STAFF REPORT
(Preliminary Plat)

CASE NUMBER: S/D 87-72 - BOEING HI-TECH OFFICE PARK
OWNER/APPLICANT: Boeing Military Airplane Company
SURVEYOR/ENGINEER: Professional Engineering Consultants, P.A.
LOCATION: Northwest corner of 47th Street and Oliver.
SITE SIZE: 24.0 Acres
NUMBER OF LOTS:
Residential:
Office:
Commercial:
Industrial: 2
Total: 2
MINIMUM LOT AREA: 9.477± Acres
CURRENT ZONING: "E"
PROPOSED ZONING: "E"

STAFF REPORT
(Final Plat; Preliminary Approved 9/10/87)

CASE NUMBER: S/D 87-72 - BOEING HI-TECH OFFICE PARK

VICINITY MAP:

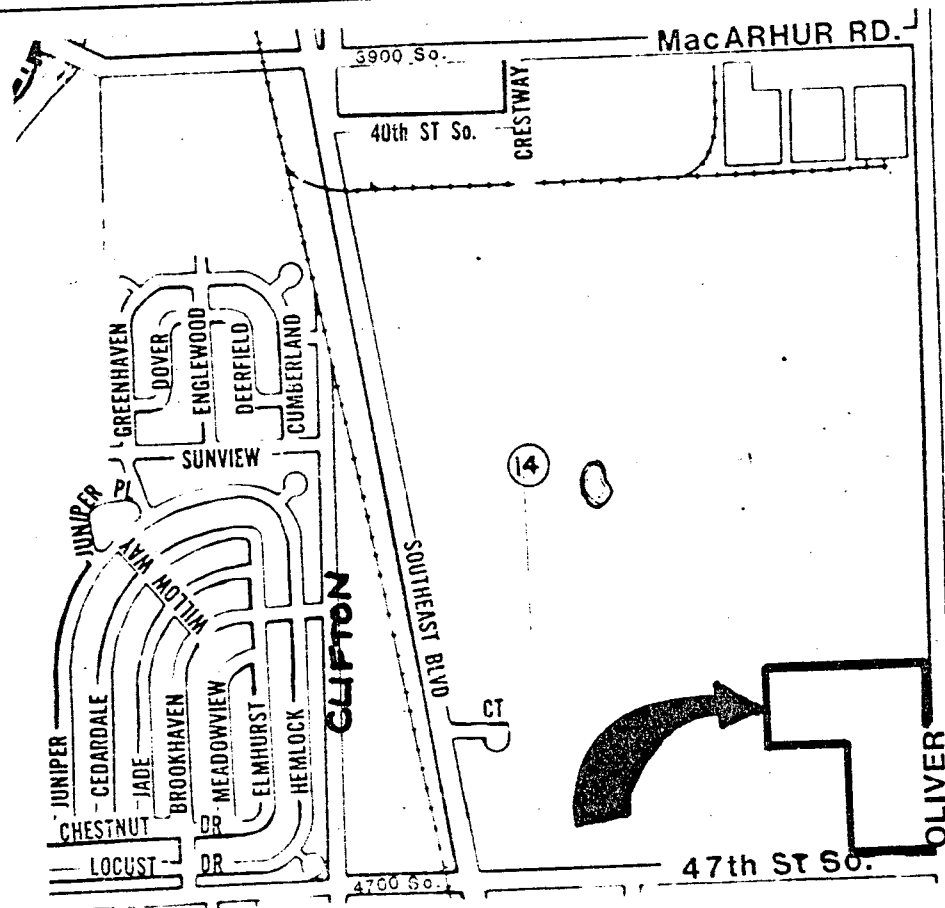
- A. The applicant shall guarantee the extension of City water to serve the lots being platted.
- B. The applicant shall guarantee the extension of sanitary sewer to serve the lots being platted. An outside-the-City sewer service application shall be executed and submitted for recording.

- C. The applicant shall guarantee any drainage improvements required by the platting of this property.
- D. The applicant shall guarantee construction of the storm sewers required by this plat.

- F. Since this property will utilize a City of Wichita water supply line, the applicant shall submit an outside-the-City water service application and associated restrictive covenant.

- G. The applicant shall submit an avigational easement covering all of subject plat and a restrictive covenant assuring that adequate construction methods will be used to minimize the effects of noise pollution in the habitable structure constructed on subject property.

- H. Prior to, or at the time of submitting the final plat, the applicant shall submit a drainage plan to County Engineering for review and approval.
- I. The final plat shall indicate angles or bearings for the perimeter of this plat.

- J. The apparent "landlocked" piece of unplatted property to the south of Lot 1, Block 1 is owned by the same firm that owns the west half of Lambert-Baird Addition. Since the property is not landlocked, it is not an issue to be raised with this plat.

- O. The representative from County Engineering should be prepared to comment on the status of the applicant's drainage concept.

VICINITY MAP:

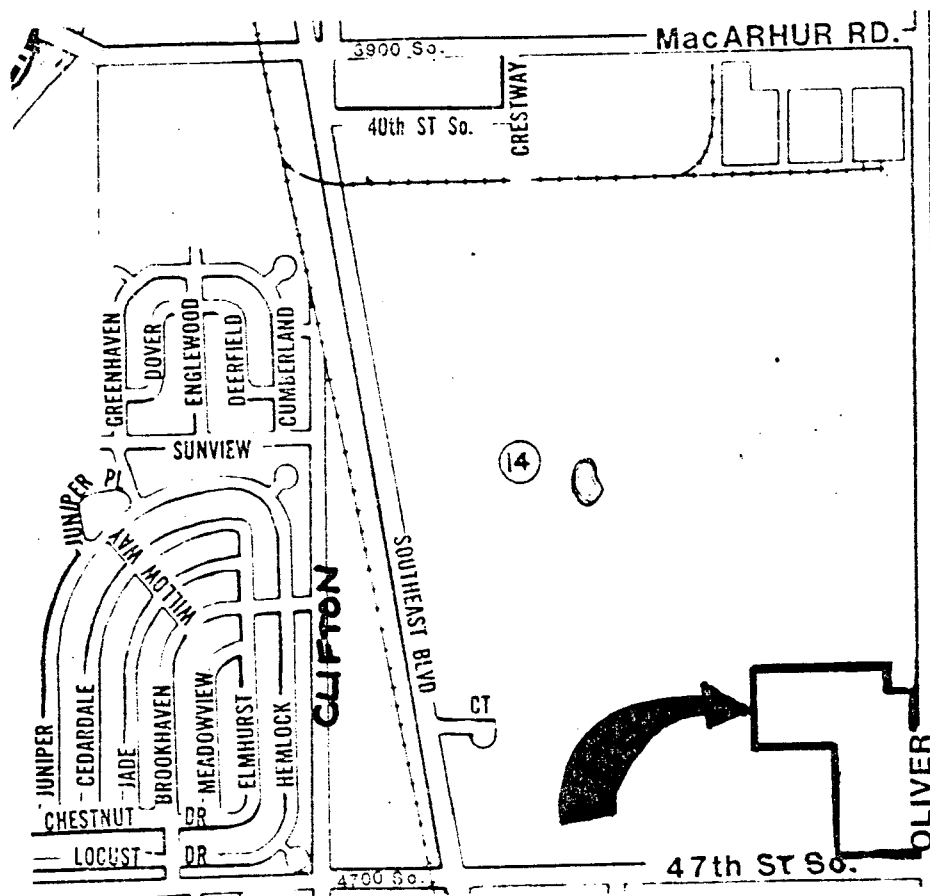
- A. Water and sanitary sewer service to this industrially zoned plat will be provided through Boeing's existing systems to the north.
- B. The applicant shall obtain, by separate instrument, the drainage covenant or agreement, from the property to the north, that is needed to permit this property to continue to drain onto that property.

- C. The final plat tracing shall indicate the following utility easements:
 - 1) A 20-foot utility easement centered on the lot line common to Lots 1 and 2.

- 2) A 20-foot utility easement adjacent to the west line of Lot 2.
- D. The final plat tracing shall indicate an appropriately wide drainage easement adjacent to the south line of Lot 1.

- E. The plat's text shall be amended to state that the location of the permitted openings to Oliver and 47th Street South "shall be determined by the appropriate Engineer".

- H. Perimeter closure computations shall be submitted with the final plat tracing. Section 5-101(C).
- I. Recording of the plat within 30 days after approval by the City Council.

- J. The representative from the County Engineer's office should be prepared to comment on the status of the applicant's drainage plan.
